Gachsaran Polymer Industries Company	Gachsaran Polymer Industries Company HDPE Plant		
	General Arrangement Drawing (2D) (*Tie-In Points , Skid Dimensions & Orientation, Including Instrument, Junction Box and Local Panel Location Layout & Instrument Cable routing.) for Refrigerator Package	 	
PO No.: GPIC-PT-MA-PO-000-3029	Document Number: VD-GPIC-MA-3029-3029-0062	Rev. 02	Page 1 of 11

General Arrangement Drawing (2D) (*Tie-In Points , Skid Dimensions & Orientation, Including Instrument, Junction Box and Local Panel Location Layout & Instrument Cable routing.) for Refrigerator Package

BACK VIEW

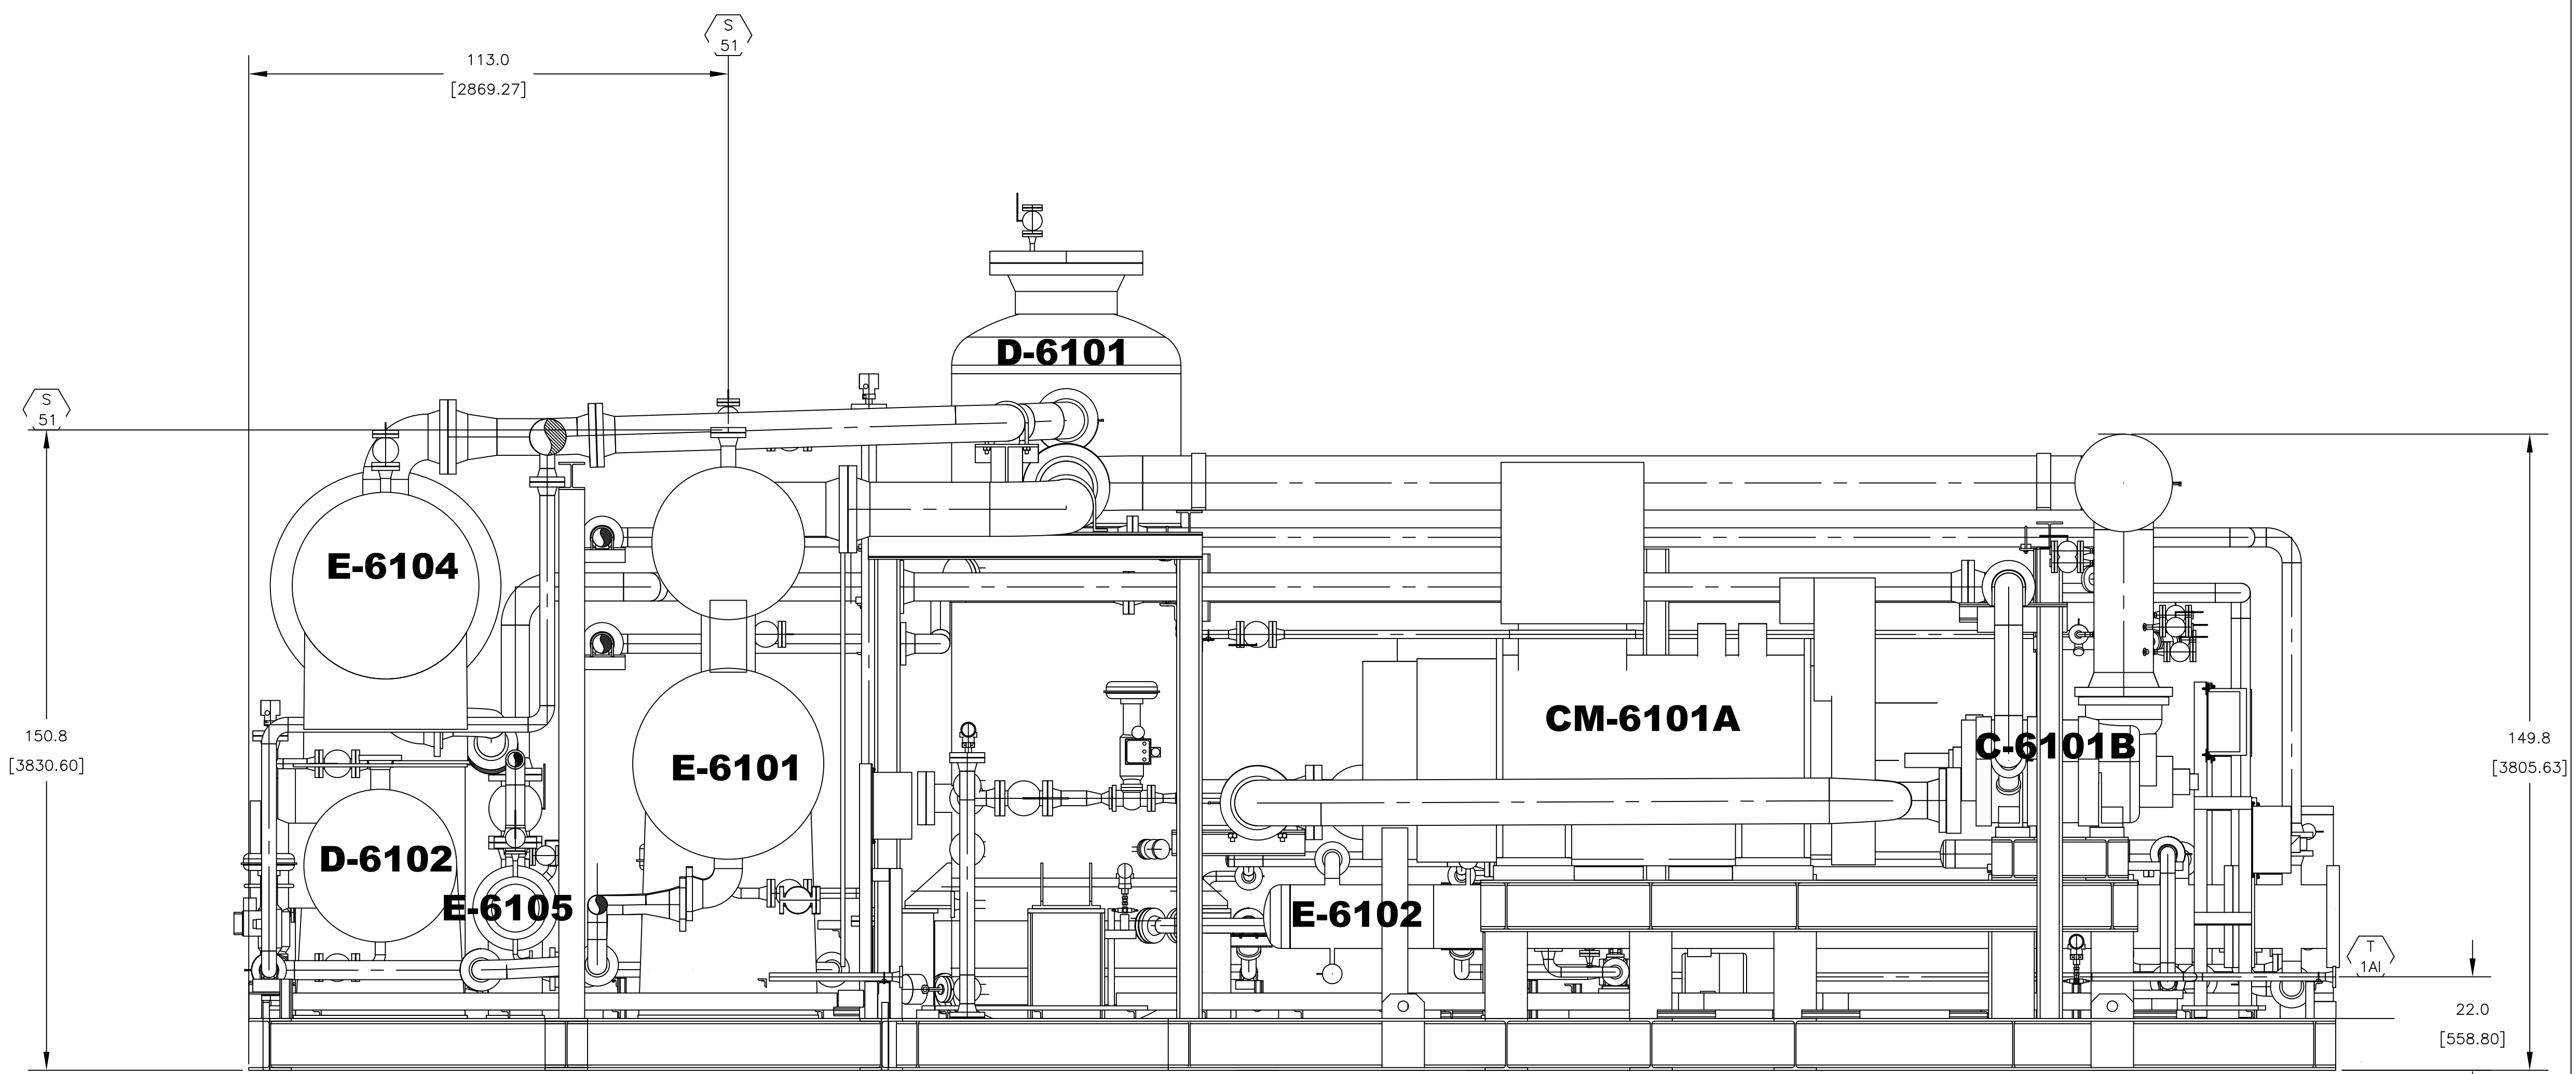
The set of tags (T) should be specified in this view.
